<b>Docket Number:</b>	21-AFC-02
<b>Project Title:</b>	Willow Rock Energy Storage Center
<b>TN #:</b>	261315
<b>Document Title:</b>	Willow Rock CURE Data Request 2 Response
<b>Description:</b>	N/A
<b>Filer:</b>	Kathryn Stevens
<b>Organization:</b>	WSP USA Inc.
<b>Submitter Role:</b>	Applicant Consultant
<b>Submission Date:</b>	1/27/2025 4:45:40 PM
<b>Docketed Date:</b>	1/27/2025

**Willow Rock Energy Storage Center (21-AFC-02)**  
*California Unions for Reliable Energy (CURE) Data Request Response Set 2*

**Legend**

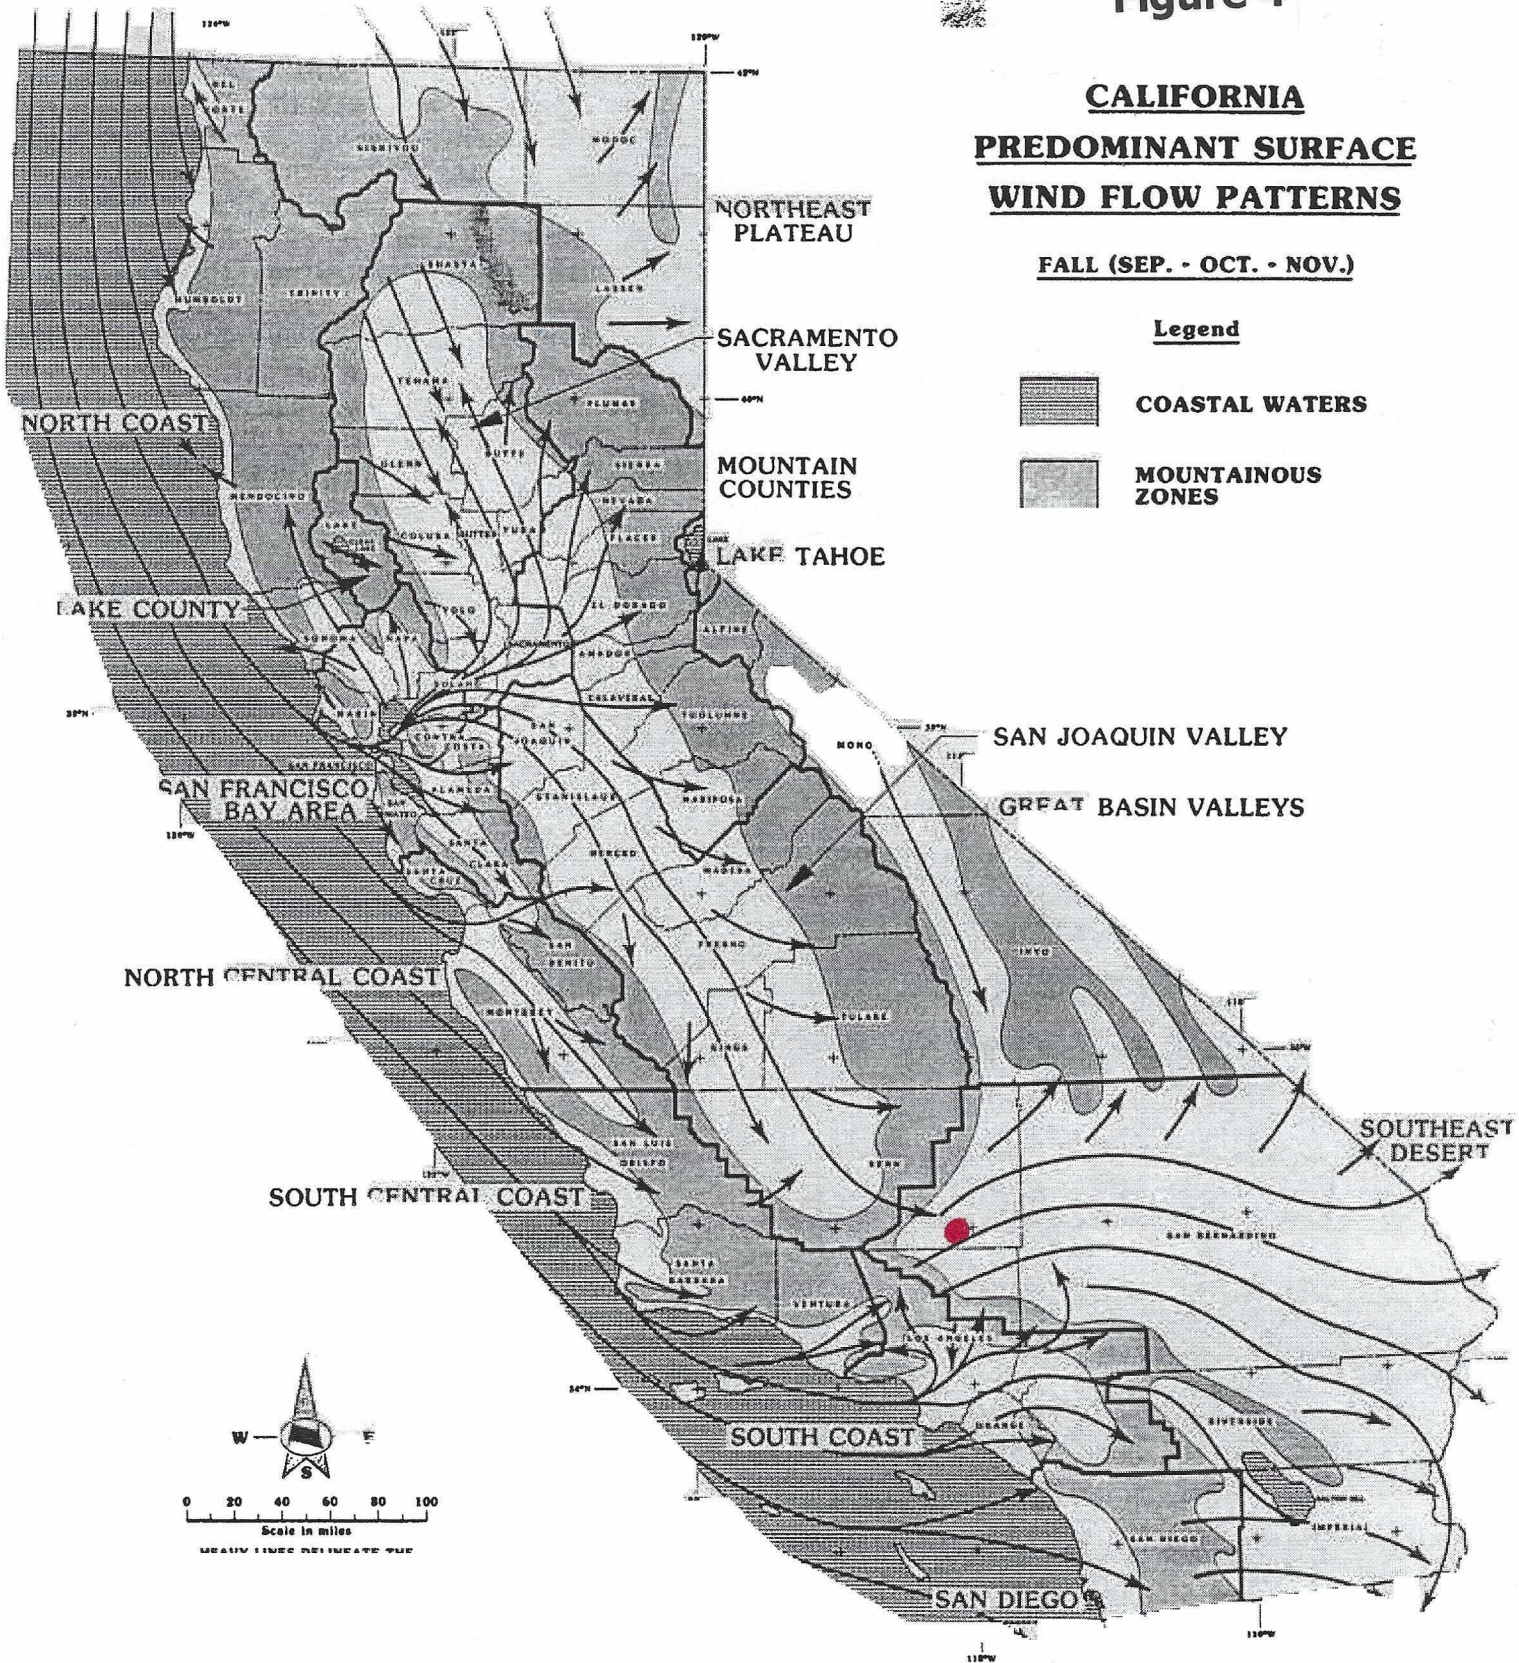
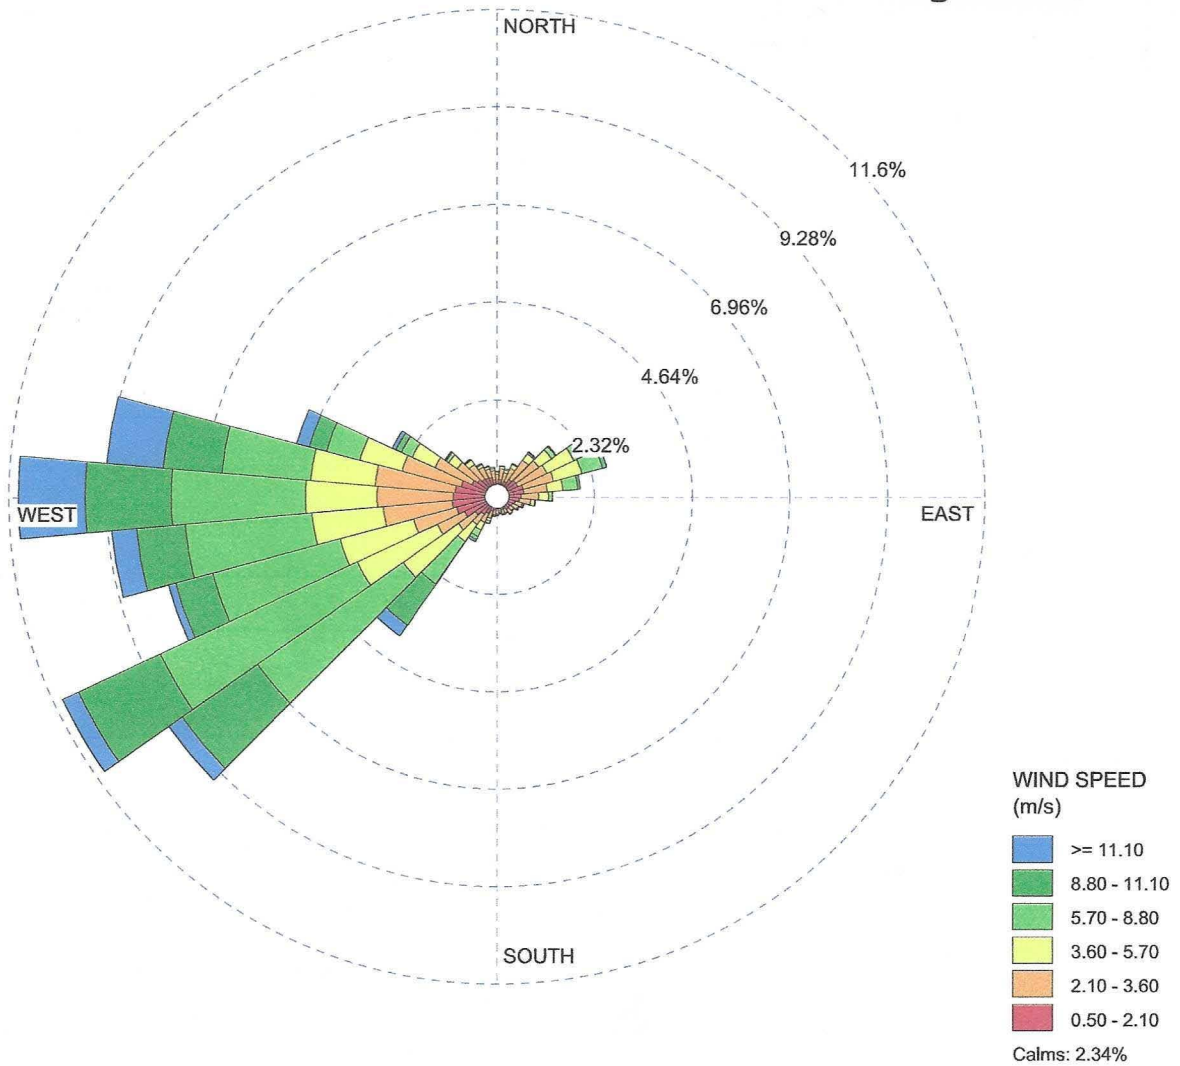
**DR107:** Explain why three monitoring stations are used to assess criteria pollutant concentrations.

A review of the California Air Resources Board (CARB) historical wind fields as well as the 5-year wind rose prepared by the Applicant's consultant, and included in **Attachment DR107-1**, indicates that an overwhelming percentage of winds originate from the west-northwest through southwest. Lancaster lies approximately 16 miles to the south-southeast of the project site, while Palmdale lies approximately 24 miles to the south-southeast of the project. The Mojave 58 Business site lies approximately 12.9 miles north-northeast of the proposed project site. Based on **Table DR107-1** monitoring site locations and the annual wind field flow patterns (**Attachment DR107-1**), neither Lancaster nor Palmdale background air quality will influence the project site background concentrations in any meaningful way as a majority of these concentrations will be transported towards the east, away from the proposed project site. However, for NO<sub>2</sub> and CO background data, Lancaster was the only monitoring station within the air basin and was selected in part due to the heavily urban-influenced concentration data the Division Street monitoring station collects. Thus, use of this background data would conservatively characterize the site air quality for purposes of the modeling study. Note that background CO monitoring data is no longer collected within the air basin after 2021.
